ADDENDUM NO. 1

T-675-24

Allendale Long Term Care Home Site Rehabilitation, Milton, Ontario

This addendum, issued Tuesday, June 25, 2024, must be incorporated into and made part of the above noted Request for Tender Document.

Appendix 2 – Tree Protection Plan (Preview – to be printed to scale from separate PDF)

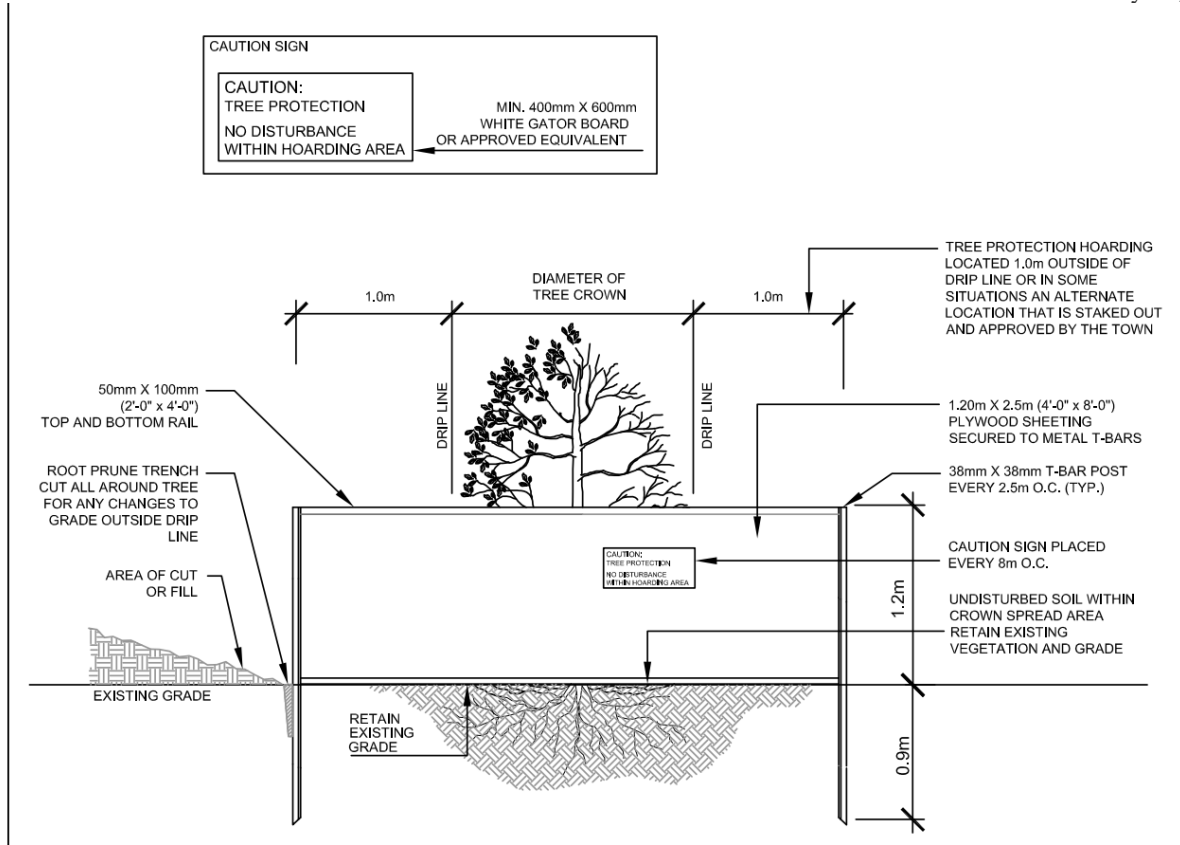
- Tree Protection Signage (Appendix 4) must be posted on the fence to indicate that it delineates a tree protection zone.
 - 13 trees (#8-9, and 14-24) are recommended to be preserved with tree protection fencing installed as shown in the Tree Preservation Plan (Appendix 2).

- Tree protection fencing should be installed around Trees #1-4 and 10-13 as shown in the Tree Preservation Plan (Appendix 2) and should be built as per the Town of Milton’s Std. No. P-1 Tree Protection Fence detail (Appendix 3).
